PZ&B Combination Staff Memorandum: Architectural Commission and Town Council

SUBJECT: ARC-23-123 (ZON-23-105) 1186 N OCEAN WAY

MEETING: NOVEMBER 20, 2023

Variance 2 Diagram, Sheet A0.12

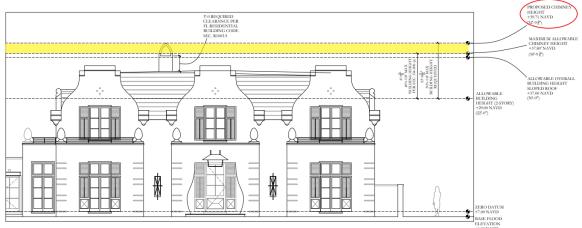
The applicants have included a variance diagram on Sheet A0.12 of the architectural plan set, which illustrates the pool location and the placement of the pool heater. Per the diagram, the pool heater will be located 27'-¼" from the pool water's edge, on the opposite side of the garage, adjacent to the pump and filter. Additionally, the pool heater is placed at 7' off the rear property line, in lieu of the 10' required. As the pool heater exceeds the maximum separation distance and encroaches into the pool heater setback, **Variance 2** is required:

Code Section	Required	Proposed	Variance
Variance 2: Sec. 134-1728(c)(2)	25' Max. Separation Distance	27'-¼" Separation Distance	2'-1⁄4''
	10' Min. Setback	7' Setback	3'
